November 20, 1979

## INNER PRIMARY CHAIN HOUSING/1200 AND 1340 CC MOTORCYCLES

FIGURE 1. INNER PRIMARY CHAIN HOUSING

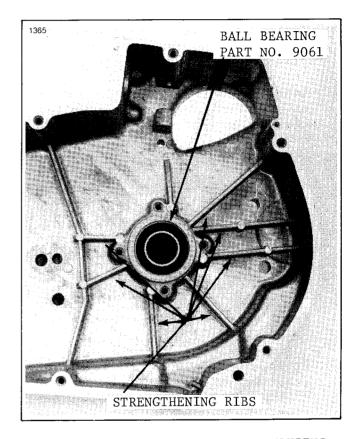
The chain housing ball bearing, Part No. 9061, located within the inner primary chain housing has exhibited shortened 1200 life in some motorcycles. The bearing wears at an accelerated rate and must be replaced at frequent intervals. This can be caused a slight misalignment of transmission shaft within the housing. This causes excessive sideloading and the walls of the housing can flex with the shaft and accelerate bearing wear.

An improved, strengthened inner primary has been put housing chain production that should minimize this with improved occurrence along transmission shaft alignment techniques at York. The inner wall of the housing has been strengthened with ribs which increase the stiffness of the wall and greatly reduce flexing of the housing. (See Figure 1.) These improved housings were put into production above V.I.N. number 25186 J0 on all 1200 and 1340cc models, and all Parts and Accessories stock contains the improved design. (See Paragraph 13 for affected part numbers and models.)

Whenever you encounter a motorcycle with recurring chain housing bearing failure, check for proper alignment of the transmission shaft and inspect the inner primary chain housing for evidence of this condition. Look for cracks around the bearing and inner walls of the housing. If such cracks are evident, replace the entire inner housing.
